NO:	NT-092	**PRODUCT:**	NV3W HMI Terminals
DATE:	February 2015	**TYPE:**	Partial Discontinuation Notice

Discontinuation and Recommended Replacements for Select NV3 Series HMI

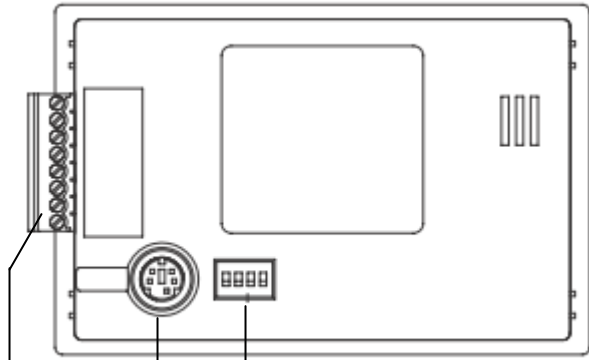
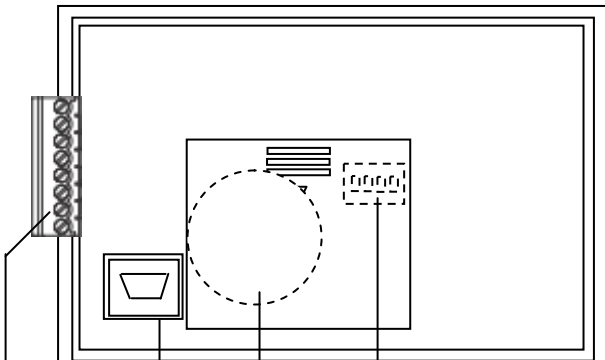
Select NV3 series HMI terminals will be discontinued and replaced with a newer V1 series. The new V1 series features these improvements:

- Larger, higher resolution display for easier reading
- Better contrast ratio to improve viewing under various lighting conditions
- USB port instead of the DIN style programming port to match newer laptop PCs
- IP67 enclosure rating now offers water-resistance instead of splash resistance

Discontinued Product	Recommended Replacement
Model NV3W-MG20L	Model NV3W-MG20L-V1
Model NV3W-MG20	Model NV3W-MG20-V1
Model NV3W-MG40	Model NV3W-MG40 -V1
Model NV3W-MR20L	Model NV3W-MR20L-V1
Model NV3W-MR20	Model NV3W-MR20-V1
Model NV3W-MR40	Model NV3W-MR40-V1

**Note:** The -V1 models above will be released at the end of May 2015.

Component Locations

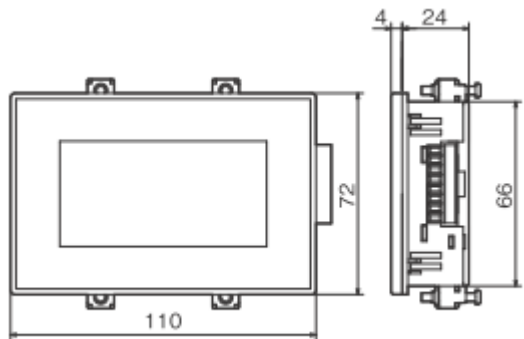
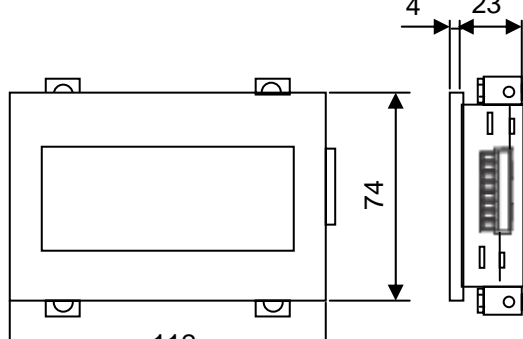
Discontinued product ModelNV3W−MG∗0∗ ModelNV3W−MR∗0∗	Recommended replacement ModelNV3W−MG∗0∗−V1 ModelNV3W−MR∗0∗−V1
Operating mode switch Tool port (NV-Designer connection port) Communications/power supply connector	Operating mode switch Battery holder USB port (Type mini-B): NV-Designer connection port Communications/power supply connector

Discontinued product ModelNV3W−MG∗0∗ ModelNV3W−MR∗0∗	Recommended replacement ModelNV3W−MG∗0∗−V1 ModelNV3W−MR∗0∗−V1
(Unit: mm) 4　24 72　66 110	(Unit: mm) 4　23 74 112

Note: Panel cutout dimensions are identical
